2016 - 2017 Cadillac ATS-V and CTS-V: GM TechLink: #16-NA-399: Information on Replacing Half Shaft Fasteners with Revised Parts

#16-NA-399: Information on Replacing Half Shaft Fasteners with Revised Parts - (Feb 28, 2017)

Subject: Information on Replacing Half Shaft Fasteners with Revised Parts

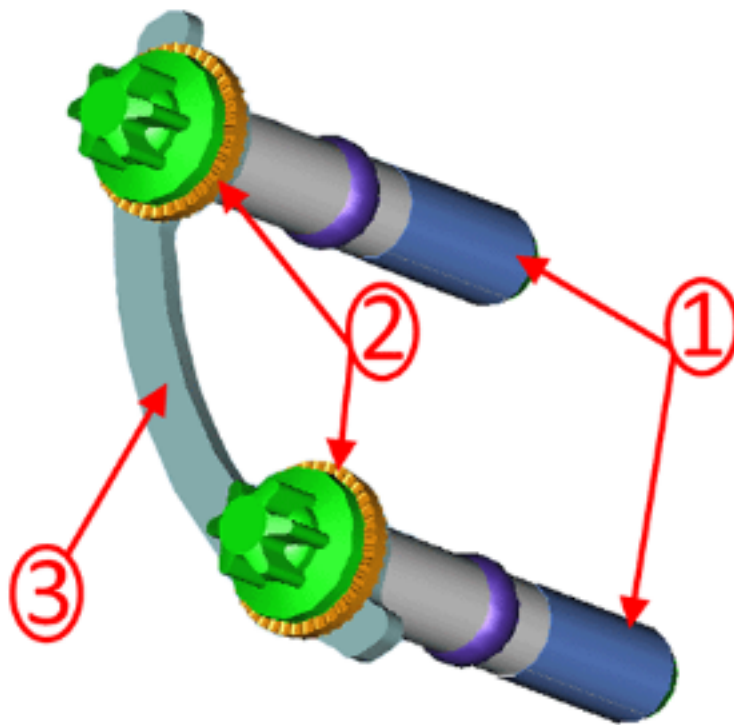
This bulletin advises the Service Technician of new retainer assemblies that are required to be installed during any repair that requires the half shaft bolts to be removed or replaced.

- Three retainer assemblies required per half-shaft.
 - Each retainer assembly consist of 2 longer length bolts (1), 2 lock washers (2) and 1 retainer (3).
 - Where applicable, each axle assembly uses 3 retainer assemblies per side.
 - Replacement of *all* retainer assemblies are required during repair.

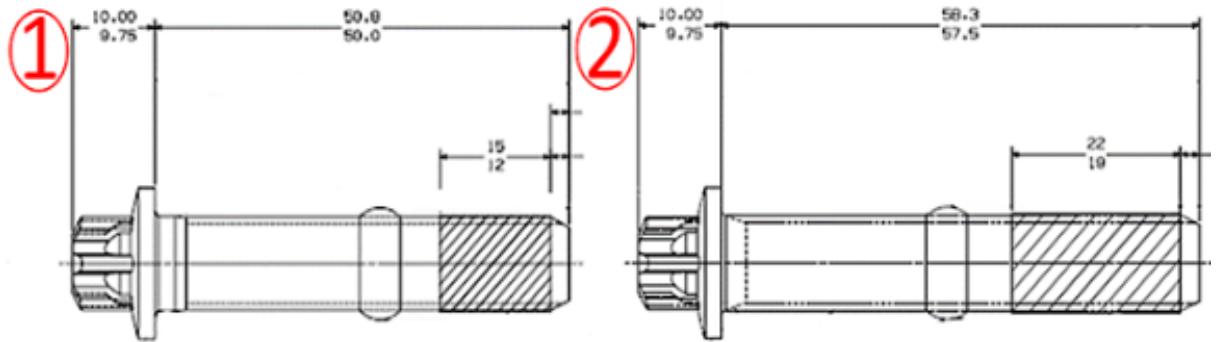
Service stock half shafts may include POA retainer assemblies that have the shorter bolt (1), these assemblies may require to be exchanged with new retainer assemblies that have the longer bolts (2).

- Remove and discard retainer assemblies.
- Install new retainer assemblies.
 - Torque bolts to proper torque specifications. Refer to

- The new half shaft bolts must be removed, measured and discarded if the length is incorrect.
